Addendum No. 8

Reference: Beverley Taylor Sorenson Center for the Arts
Southern Utah University – Cedar City, Utah
DFCM Project No. 12218730

Subject: **Addendum No. 8**

| project | Southern Utah University Beverley Taylor Sorenson Center for the Arts Utah Shakespeare Festival Facility |

First Floor - Area C
Lighting Plan

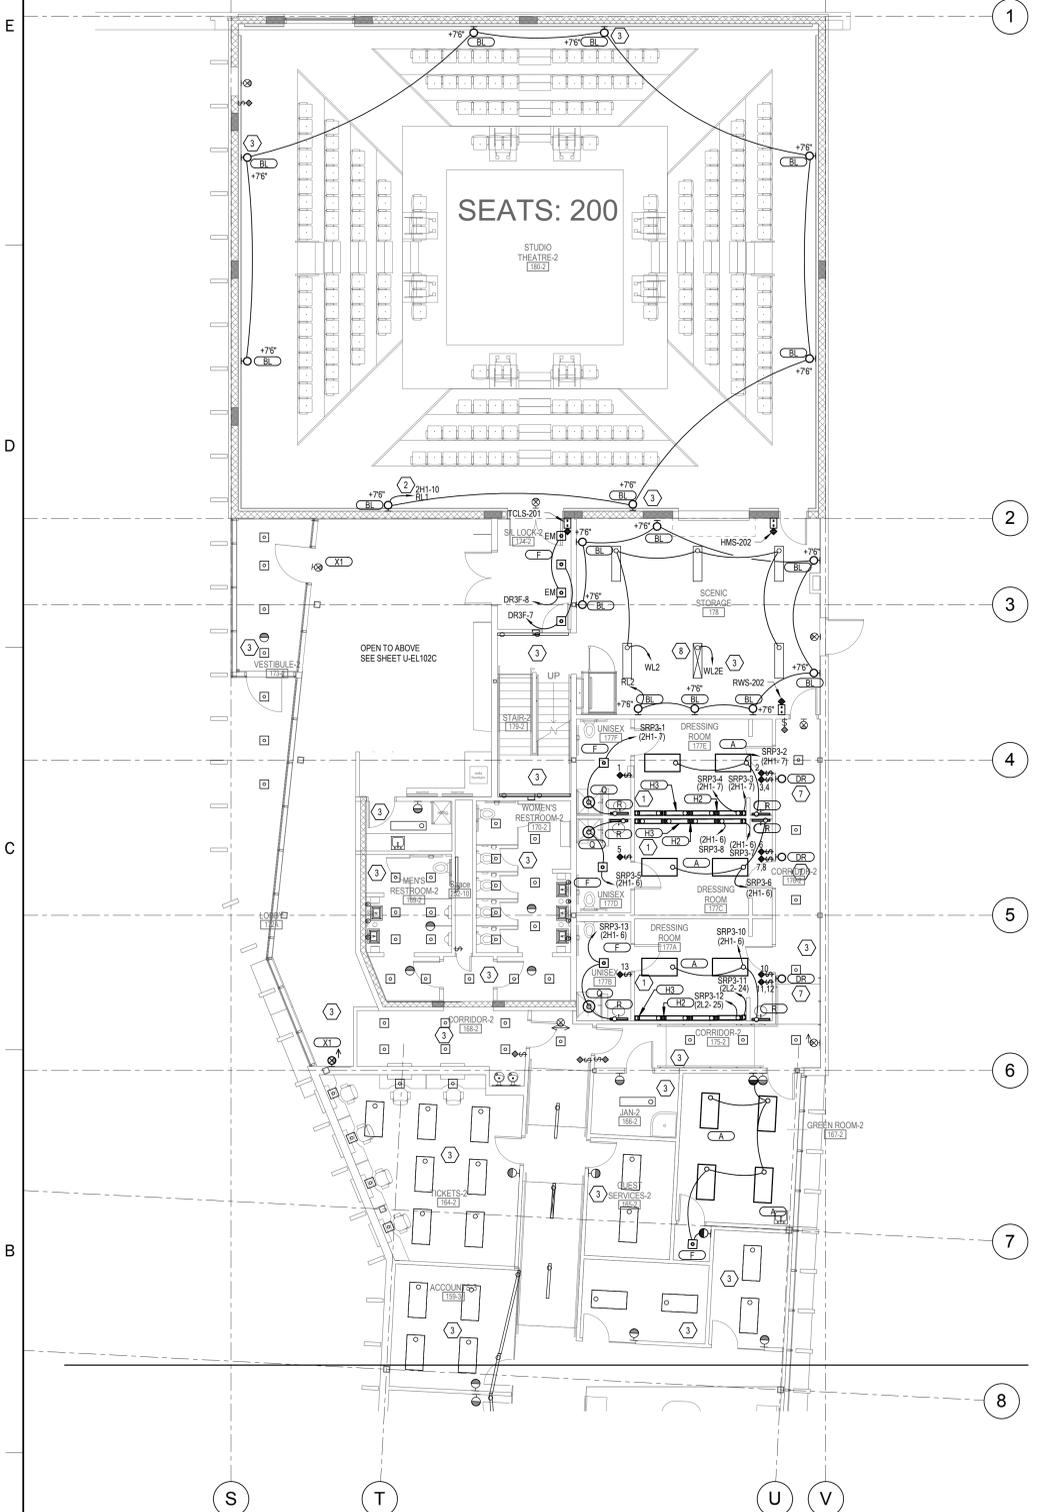
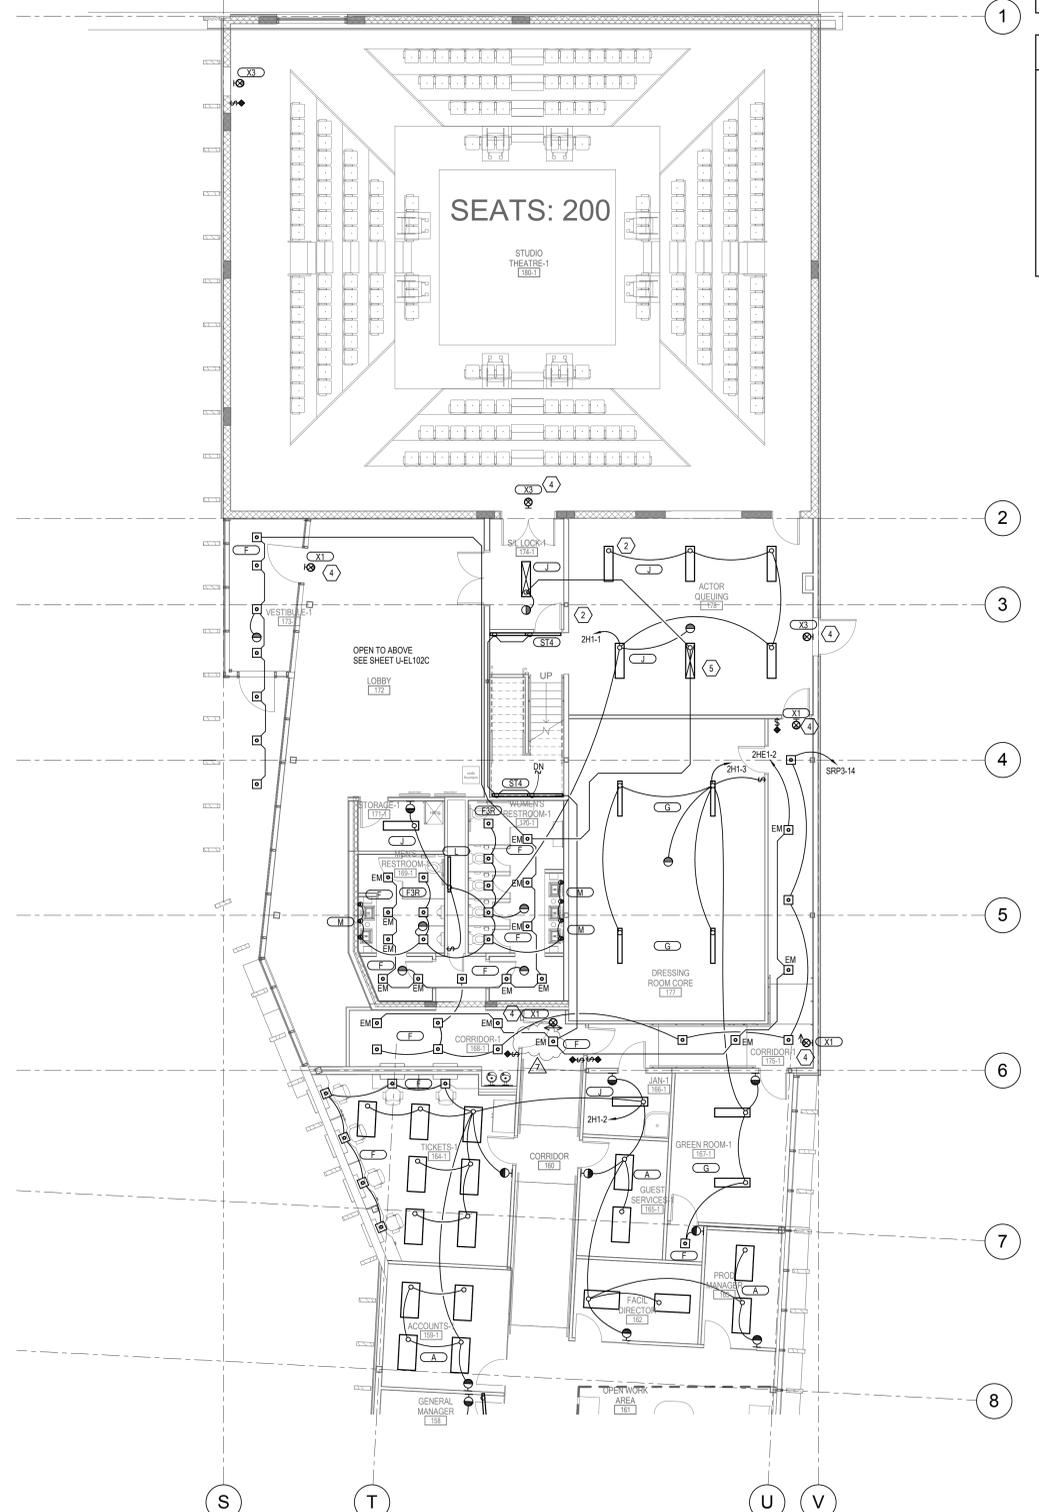
| ELECTRICAL | | | |
|------------|---------------|------------|---|
| | Clarification | U - EL101C | <ul style="list-style-type: none"> Remove emergency home run in Corridor 168-1. Tickets 164 & Accounts 159. Fixture changes were made in addendum 5 but not mentioned in narrative. See clouding of these rooms in addendum 5 for changes. |

Basement Power Plan
U-EP100

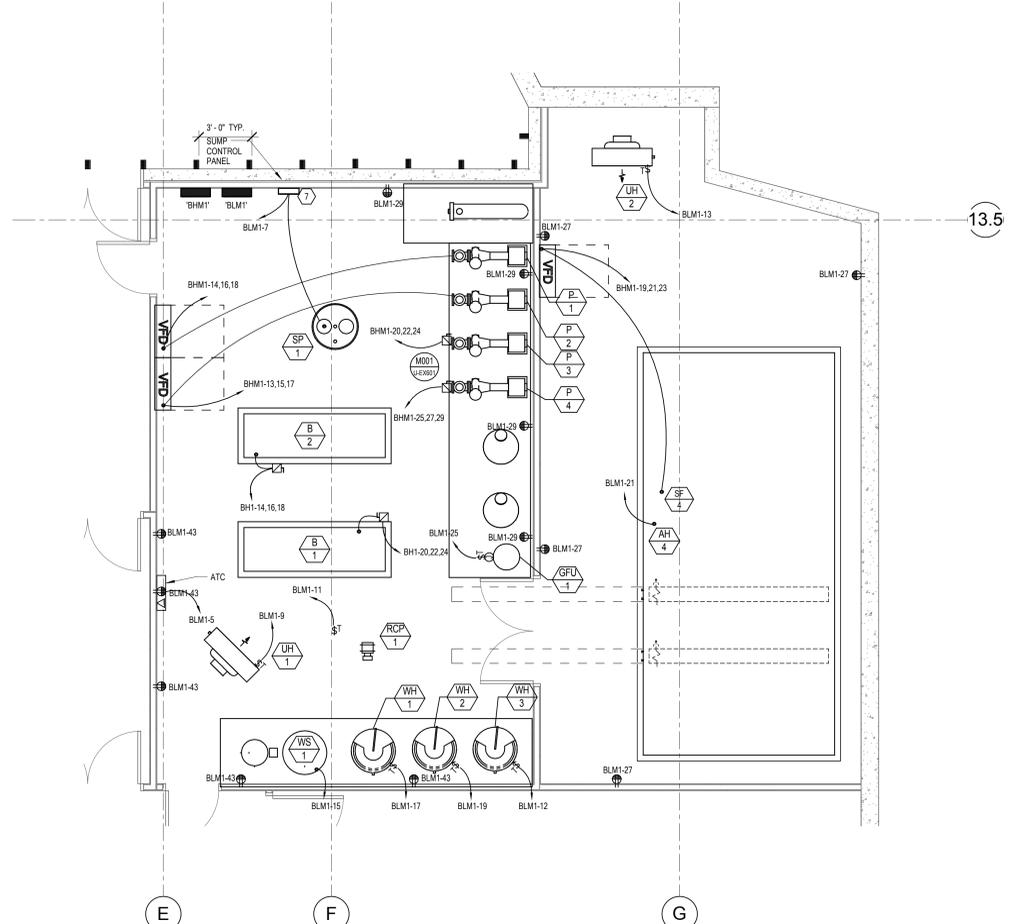
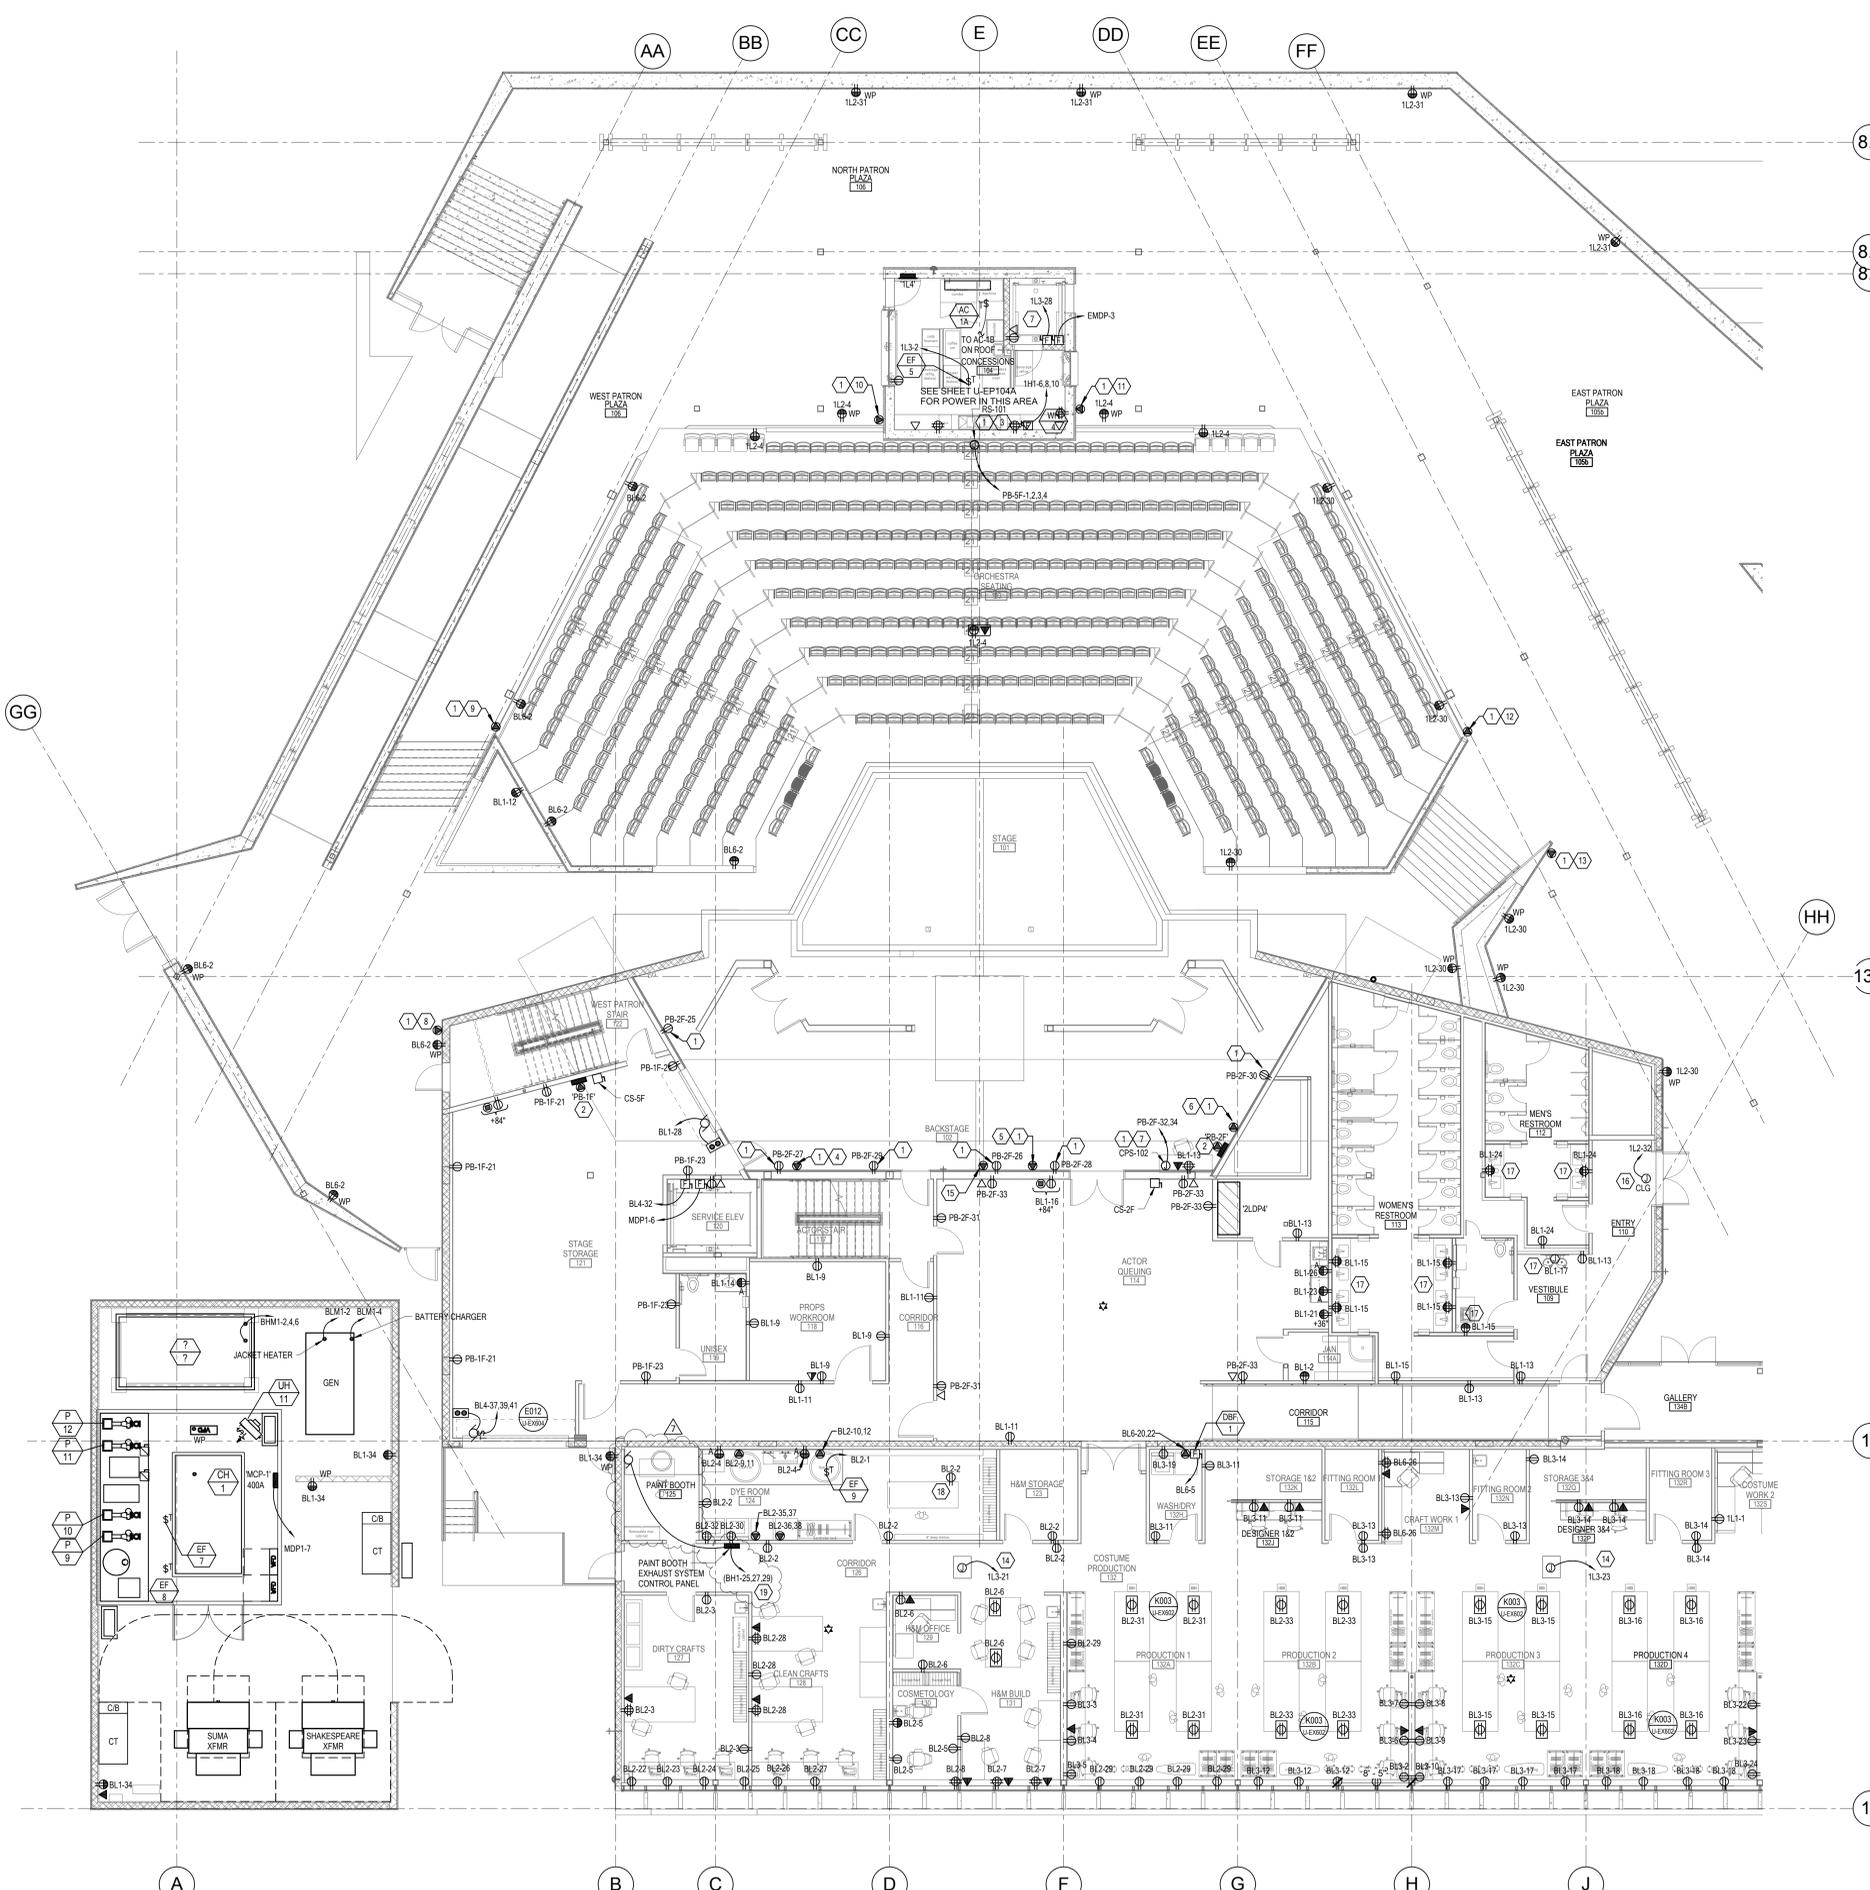
| | Clarification | U-EP100 | <ul style="list-style-type: none"> Storage/Effects 012. Provide (2) dedicated 20a circuits for sound cabinets on north wall in lieu of circuit BL2-21. Provide a 4plex outlet for each cabinet. See plans for circuit number and coordinate location of cabinet with sound drawings. Addendum, 6 indicated transformer TK4 to be in the main electrical room and Storage 006. It is in Main Elec 003 as shown on the plans. |
